Your Ref: 23/01316/F

Erection of 5 two storey age restricted dwellings (55 years) for older people with access, landscaping and associated infrastructure - Land South of Faraday House, Woodway Road, Sibford Ferris (Application No. 23/01316/F)

Figure 6 – View of Proposal from the North (Faraday House)

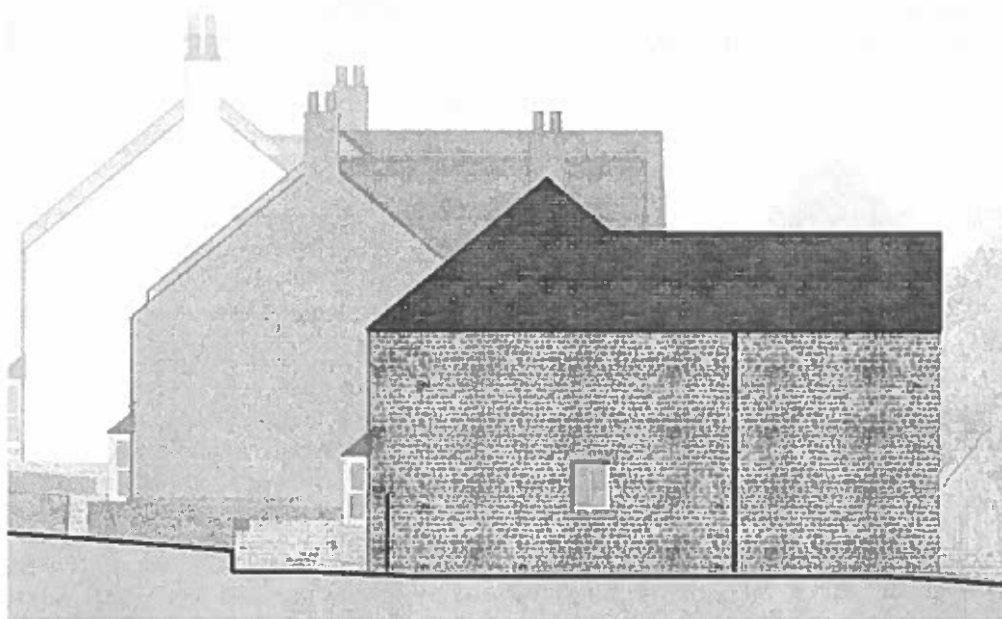
The physical impact of the dwellings – especially Plot 5 – is perhaps most acute upon Faraday House just 15 metres to the north of the site, as shown on Figure 6 taken from the application.

Where development results in prejudicial harm to the outlook of a residential property and is unduly overbearing it should be resisted as failing to achieve acceptable standards of layout, design and residential amenity and the highest possible standards of design.

In this case, the proposal would have a detrimental impact upon the residential amenities and outlook of existing neighbouring properties, which ought in the public interest to be protected. This would be contrary to Policy C31 of the Local Plan 1996, Policy ESD15 of the Local Plan Part 1, advice in the NPPF and the National Design Guide, 2021. Paragraph 126 of the NPPF states that the creation of high quality, beautiful and sustainable buildings and places is fundamental to what the planning and development process should achieve. The proposal would fall considerably short of this requirement by failing to be sympathetic to the surrounding built environment and landscape setting.
